Site Accessibility Evaluation
Americans with Disabilities Act
Title II (Public Services: State and Local Government)

CITY MAIN LIBRARY
145 Washington Ave
Santa Fe, NM 87501

Report Date: 02/03/2025

Finding: 1

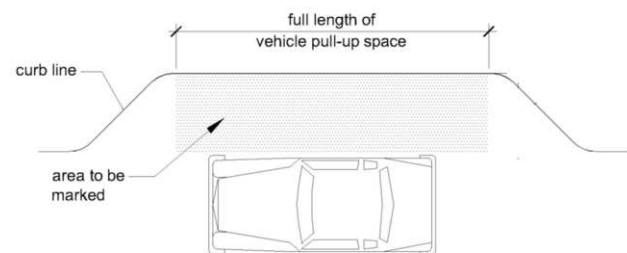
The access aisle and/or the vehicle pull-up space surface is not firm, stable, and slip resistant.

Access aisle is not clearly visible or defined and also irregular surface in pavement need to be addressed.

Clean, refinish and redefine the surface of Passenger Loading Zone.

Finding: 2

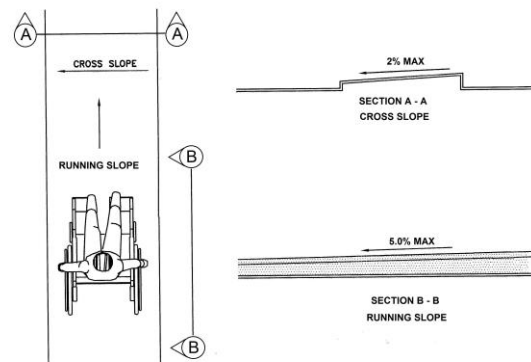
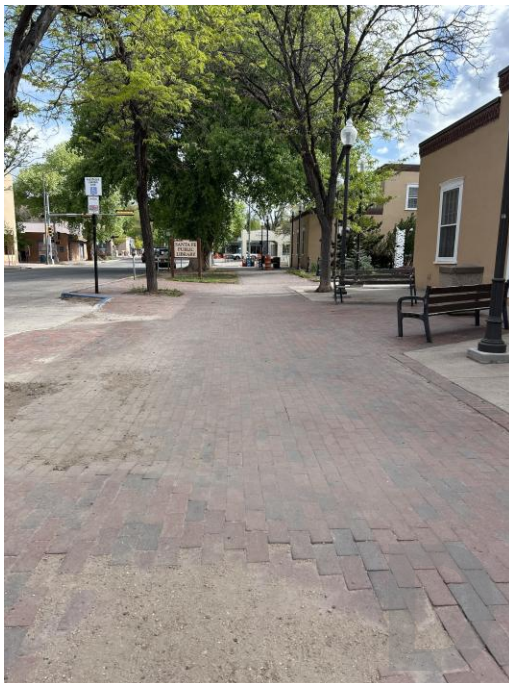
The accessible path of travel has cross slopes greater than 2%.

The cross slope of the pedestrian access route exceeds the maximum required slope of 2% due to the brick pavers

Repair and correct pavers as necessary to not exceed the required maximum cross slope of 2%

Finding: 4

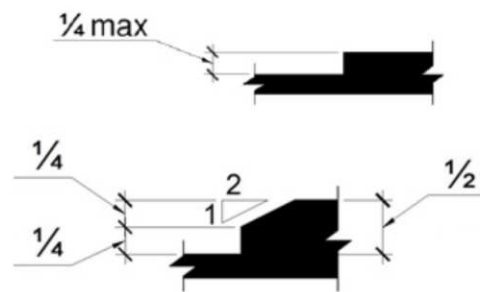
The walkway contains abrupt vertical edges and/or variations over a 1/2 inch.

Vertical changes in level exceeds 1/2 inches in the pedestrian access route at passenger loading zone.

Modify, repair, or resurface to provide a level surface with vertical changes not to exceed 1/4" in height.

Finding: 7

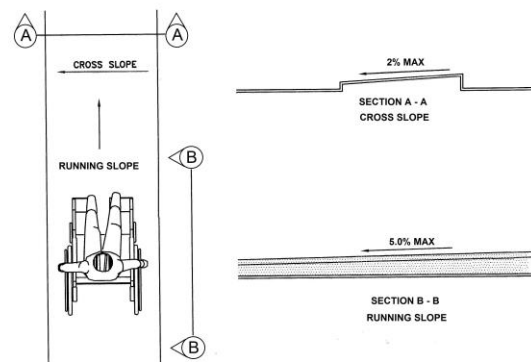
The accessible path of travel has cross slopes greater than 2%.

At drive way location, cross slope is 2.9%

Finding: 8

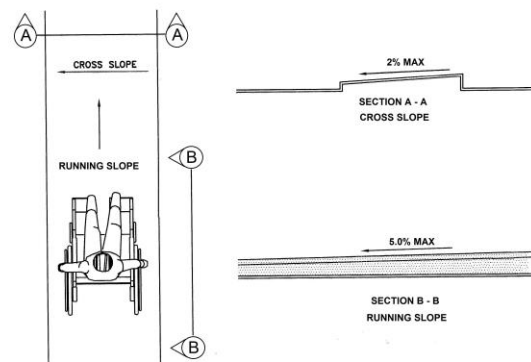
The accessible path of travel has cross slopes greater than 2%.

Adjacent to driveway, portions of the brick paved route are 5.6% or greater.

Finding: 9

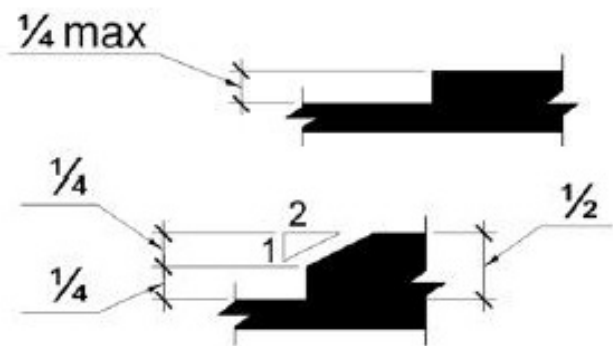
The walkway contains abrupt vertical edges and/or variations over 1/4 inch.

Due to tree planters, pedestrians access route have vertical changes that exceed 2/4 inches

Finding: 11

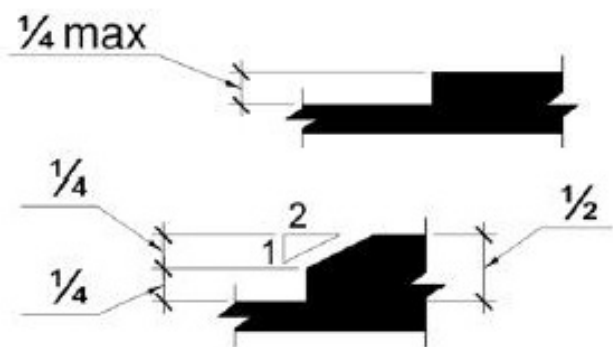
The walkway contains abrupt vertical edges and/or variations over 1/4 inch.

Throughout route existence of various change in elevation exceeding 1/4 inches in height due to tree planters, etc.

Finding: 12

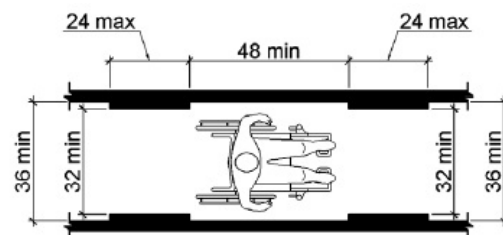
The route of travel does not provide the required minimum width.

At tree planters, width is reduced to 28 inches

Finding: 13

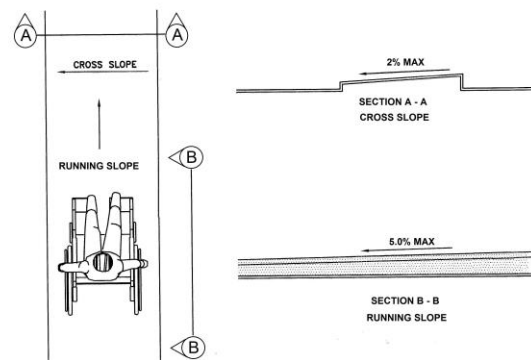
The accessible path of travel has cross slopes greater than 2%.

Throughout pedestrian route the cross slope exceeds 2%

Finding: 14

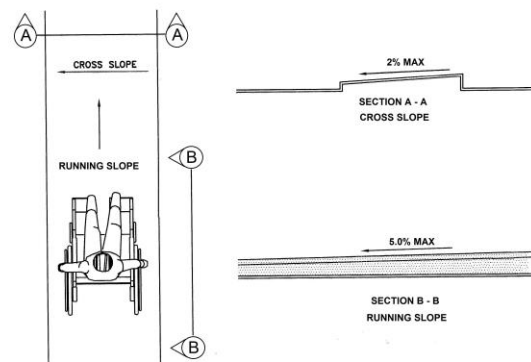
The accessible path of travel has cross slopes greater than 2%.

At driveway, the cross slope is 8.7% which exceeds the 2% requirements

Finding: 15

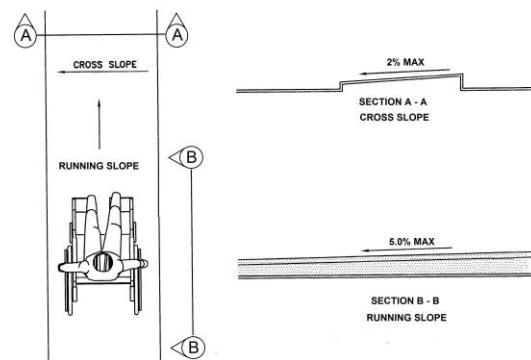
The accessible path of travel has cross slopes greater than 2%.

At driveway, the cross slope is 4.5%

Finding: 16

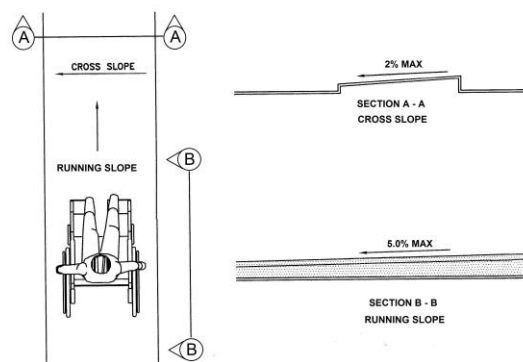
The accessible path of travel has cross slopes greater than 2%.

Throughout pedestrian route, the cross slope exceeds 2%

Finding: 17

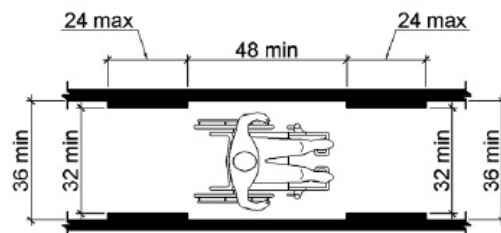
The walking surface is obstructed. A 36 inch wide minimum walking surface is required.

Existence of a trash bin has reduced the walking surface to 31.5 inches

Finding: 18

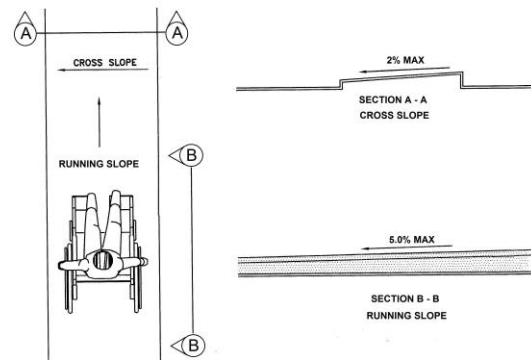
The accessible path of travel has cross slopes greater than 2%.

Exiting cross exceed 2%

Finding: 20

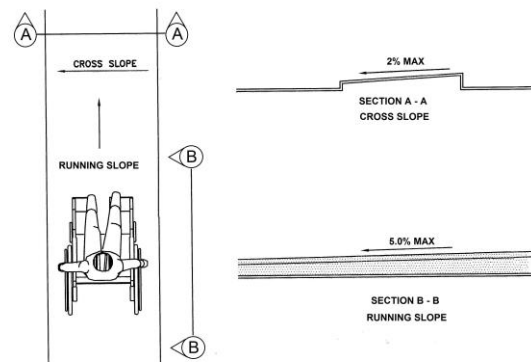
The accessible route has running slopes greater than 5% and has not been constructed as a ramp (i.e. handrails, edge protection, etc.). Cross slopes are greater than 2% across the width of the walk.

On May 9, 2024, Parking Lot was repaved. Cross & Running slopes were corrected to comply.

Finding: 23

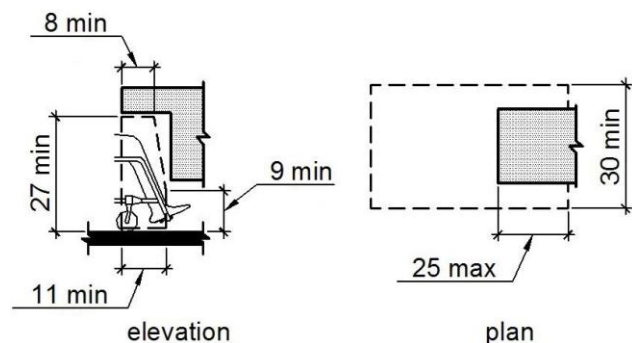
The knee clearance is not a minimum of 27 inches above the finished floor.

Desk surface is 35.5 from floor and knee space height is 33 inches.

Finding: 25

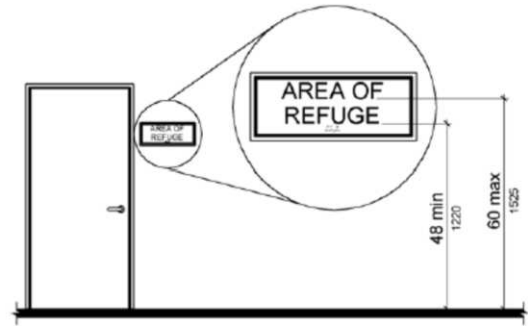
Compliant room identification signs are missing.

Throughout floor no accessible signage is provided

Finding: 26

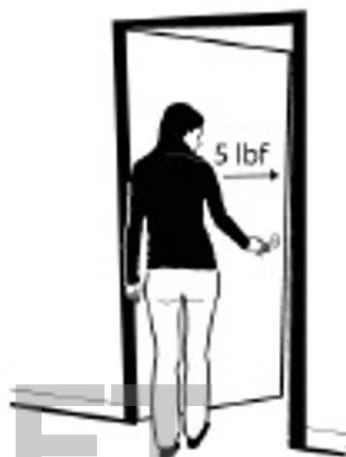
The door exceeds the maximum allowable opening force.

Push Pressure measured 12 lbs

Finding: 27

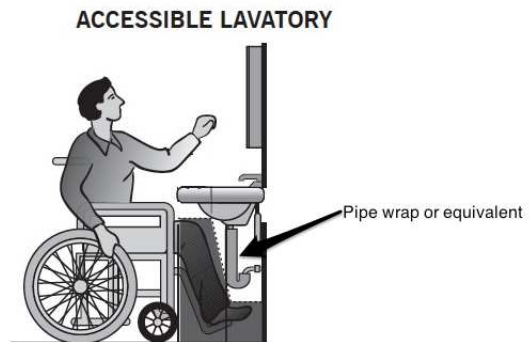
The water and drain pipes under the lavatory are not adequately insulated.

Not insulated

Finding: 28

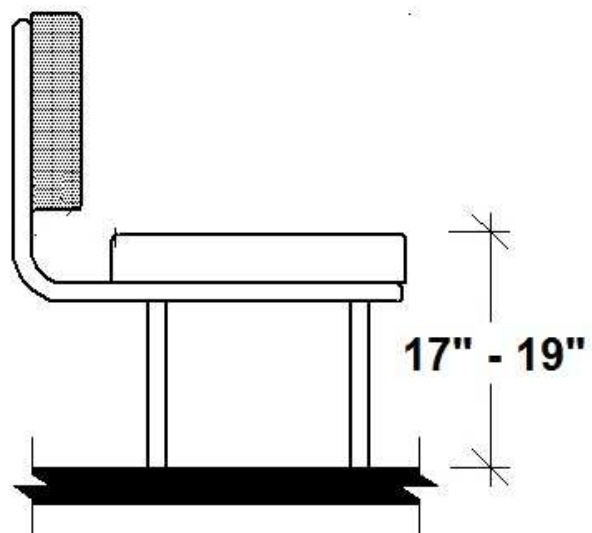
The bench seat is not within compliant height range.

19 inches
